## San Bernardino County Overnight Solar Project

# **APPENDIX A: NOTICE OF PREPARATION AND SCOPING COMMENTS**

**NOTICE OF PREPARATION OF A DRAFT EIR  
AND SCOPING MEETING**

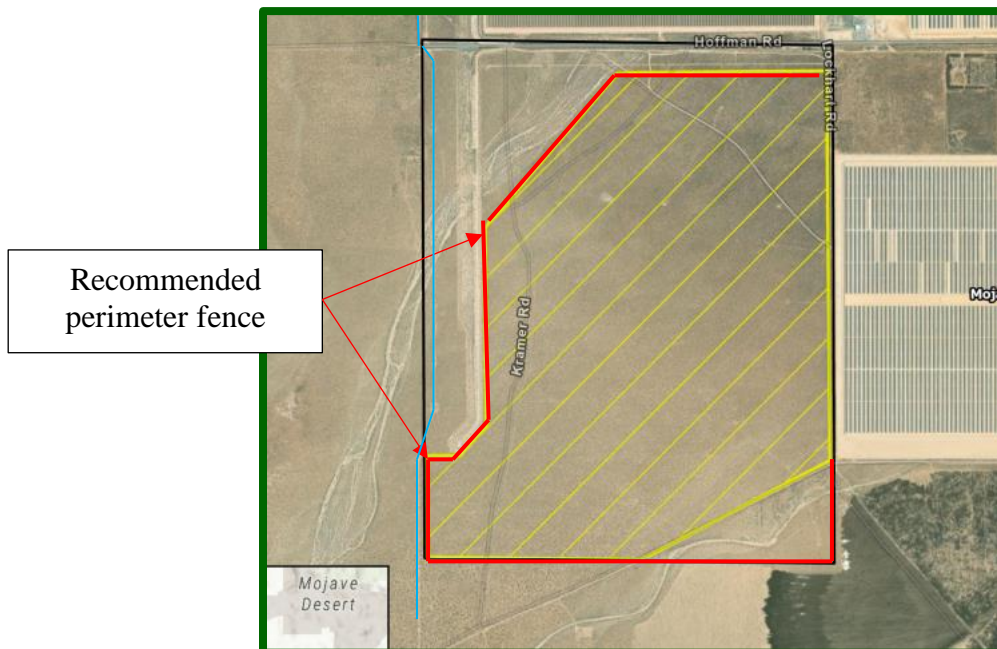
Page 1 indicates, "...panel washing would occur at least once per year and potentially up to 4 times per year. Panel washing would require up to 12 employees with water trucks and would take approximately 20 days to complete." On page 6, we also read, "Approximately 200 acre-feet of water would be used during the first year of construction." Further, "Components of the plan are likely to include water trucks to spread water, as well as road stabilization with chemicals, gravel, or asphaltic pavement to mitigate visible fugitive dust from vehicular travel and wind erosion."

Please be sure the Draft EIR addresses current aquifer characteristics and how this project, combined with the other existing and proposed solar projects, including the Desert Breeze solar project, may affect the aquifer. Our relatively more pertinent concern with the use of so much water is the attraction of known predators, including common ravens and coyotes, into the project area, potentially increasing depredation of tortoises in adjacent areas. Panel washing and dust suppression if not applied in a conscientious manner will result in water puddling onsite and runoff into adjacent areas, which are both human-subsidized water sources for these predators.
